Re: Single storey extension to front and side of existing Green Keepers Building at Edmondstown Golf Club, Rathfarnham, Dublin 16

Planning Reg Ref No. SD21A/0235

Re: Planning Reference SD21A/0235 Proposed Extension and Alterations to Green Keepers Building at Green Keepers Facility, Edmondstown Golf Club, Rathfarnham, Dublin 16

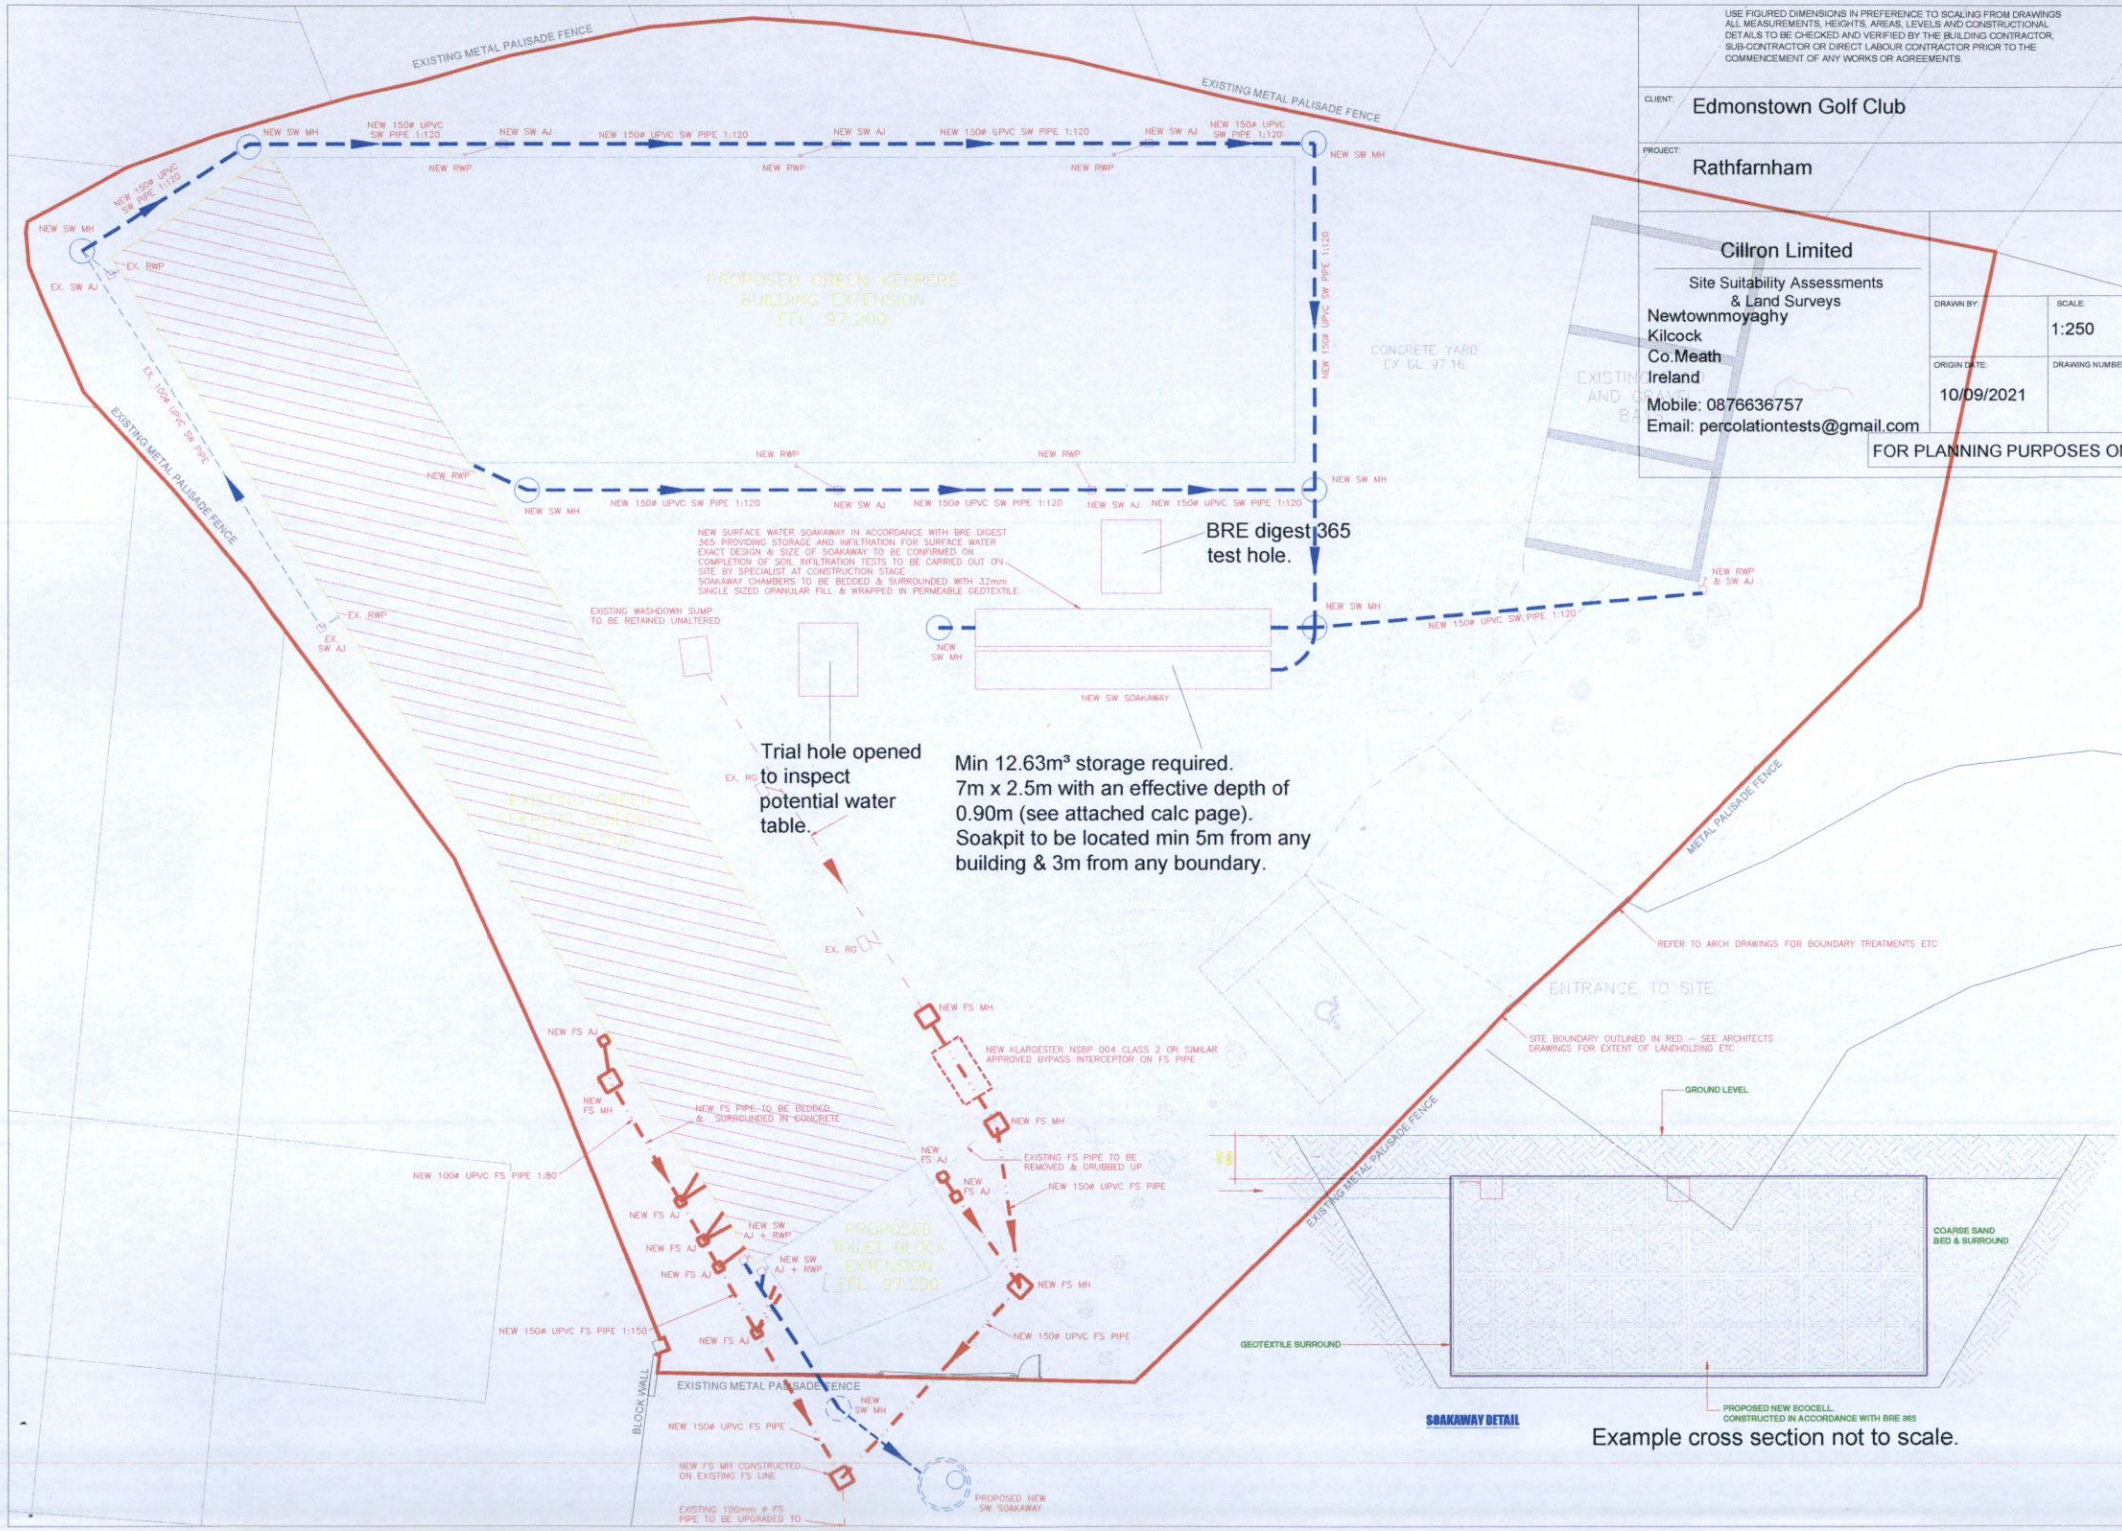
Item 3.(i)(ii)(iii)(iv); The proposed soakaway details including the plan and cross sectional views, dimensions and location are included in the BRE Digest 365 report. The proposed soakaway has been positioned based on the separation distances outlined in part 2(2) of the AI request dated 19th October 2021.

Item 3.(v); The proposed soakaway is the outfall for the surface water run-off for the proposed building extension and has been designed to store and infiltrate the surface water run-off. The site is not serviced with a storm drainage network, and it will therefore not be possible to provide an overflow connection from the soakaway to the storm drainage network.

Min 12.63m³ storage required.
7m x 2.5m with an effective depth of
0.90m (see attached calc page).
Soakpit to be located min 5m from any
building & 3m from any boundary.
